Model: All With Labrie Right Side Drive Cab Modification

Subject: Throttle Pedal Circuit Modification

**Replacement Throttle Pedal Wire
Modification**

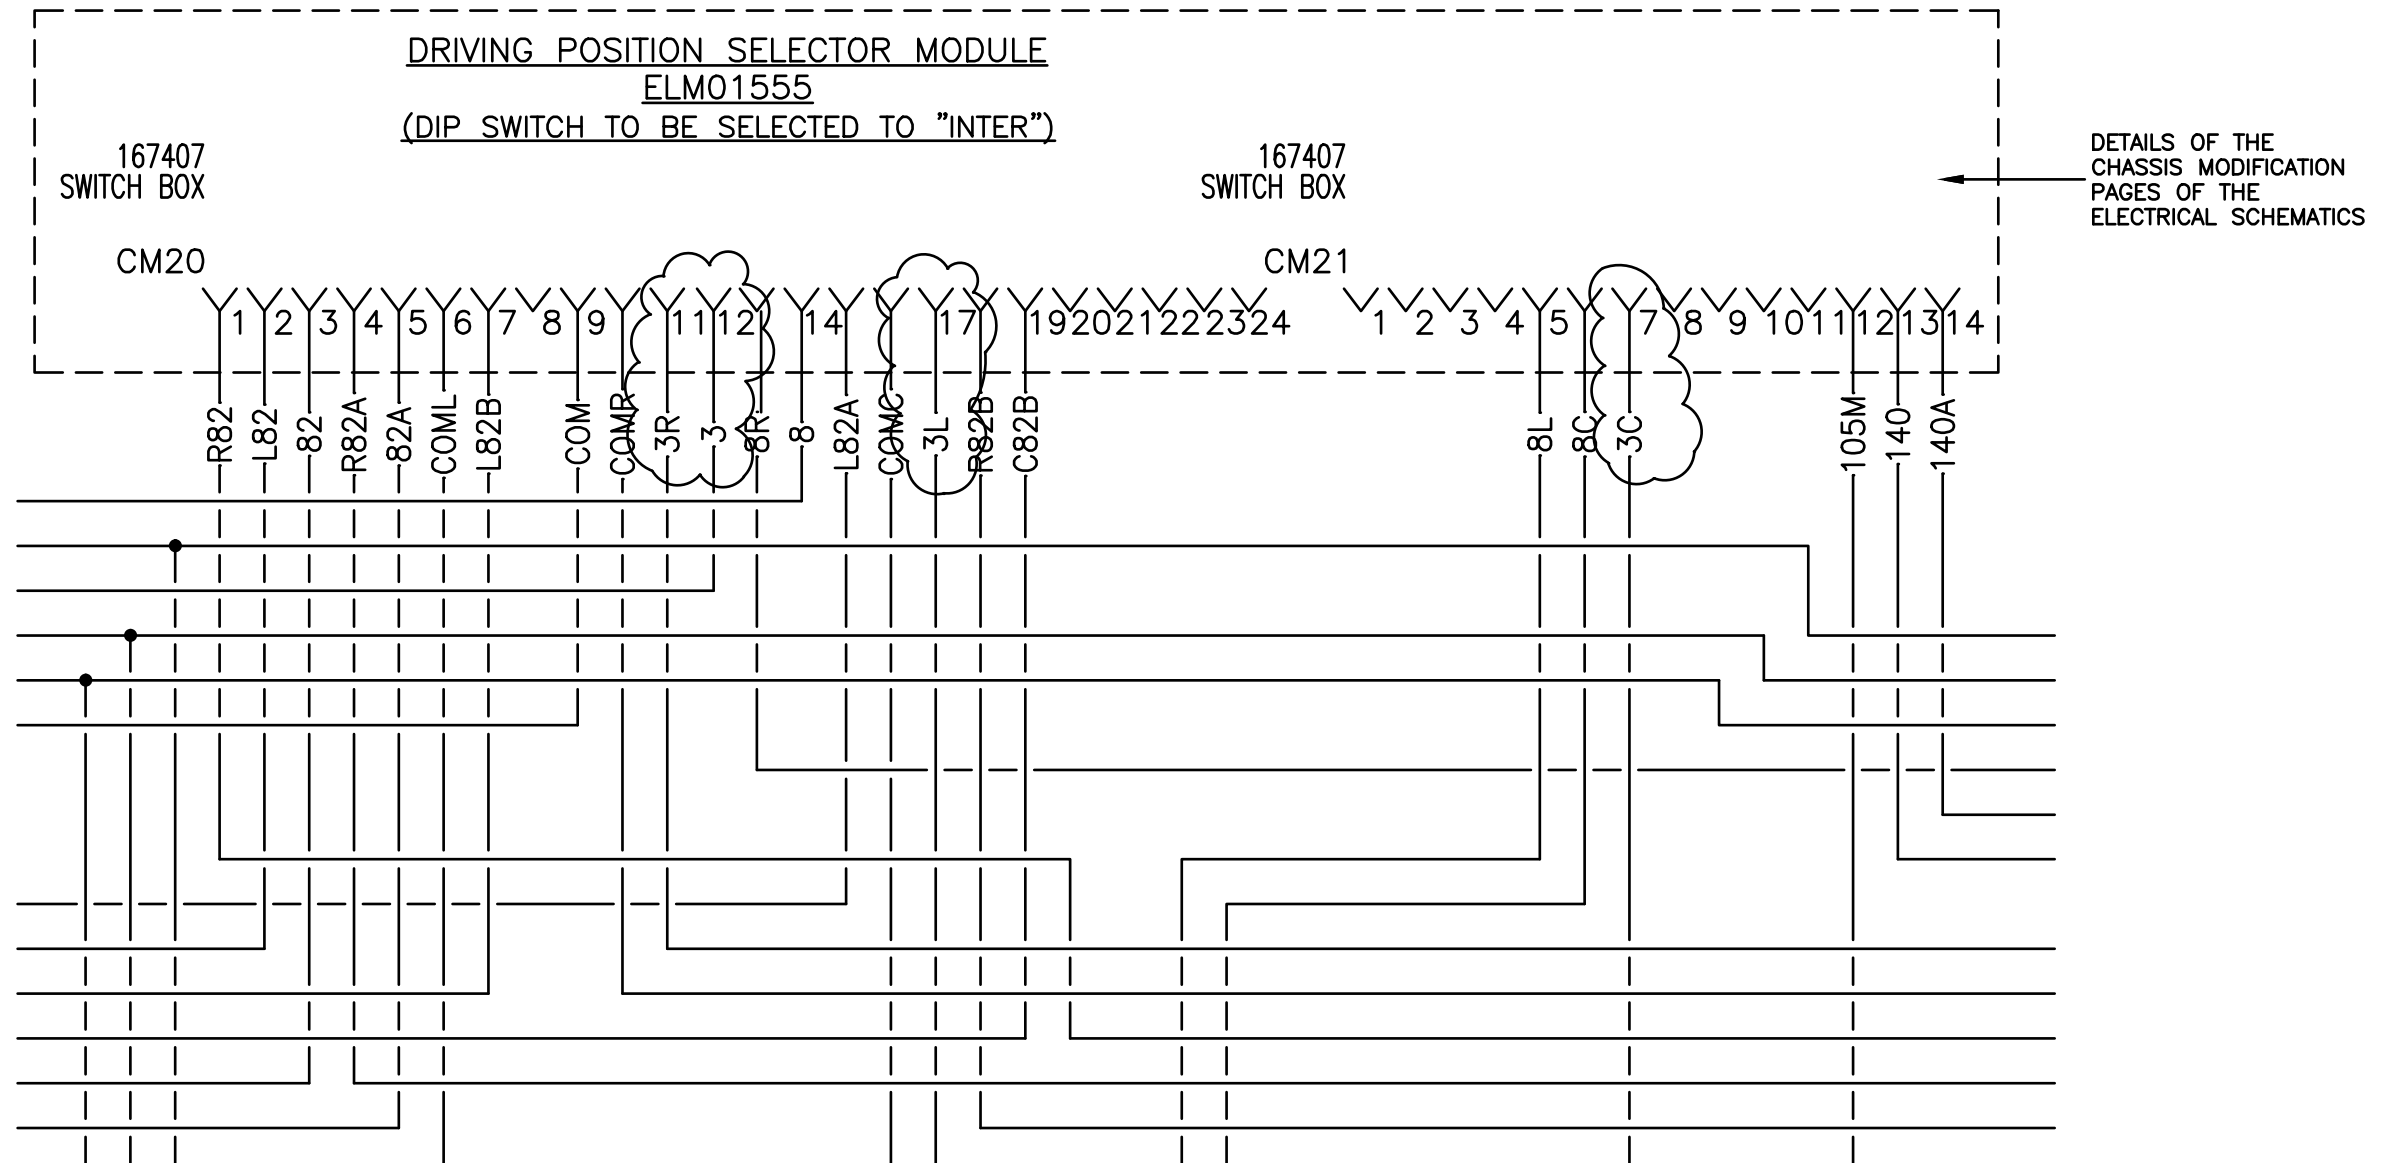
The manufacturer of the LabriePlus part number ELP01060 throttle pedal incorporated into the Labrie right side drive cab modification has changed the internal components of this assembly. This change occurred in mid-2016.

When replacing this part on a unit manufactured prior to the change, a chassis TPS fault code may be displayed. If this occurs, the throttle pedal circuit wiring must be modified to accept the revised component. The attached illustration describes the required modification.

HARNESS MODIFICATION

- 1) REMOVE IN CM20: WIRES 3R PIN 11, 3 PIN 12, 3L PIN 17
REMOVE IN CM21: WIRE 3C PIN 7
- 2) SPLICE THE 4 WIRES TOGETHER
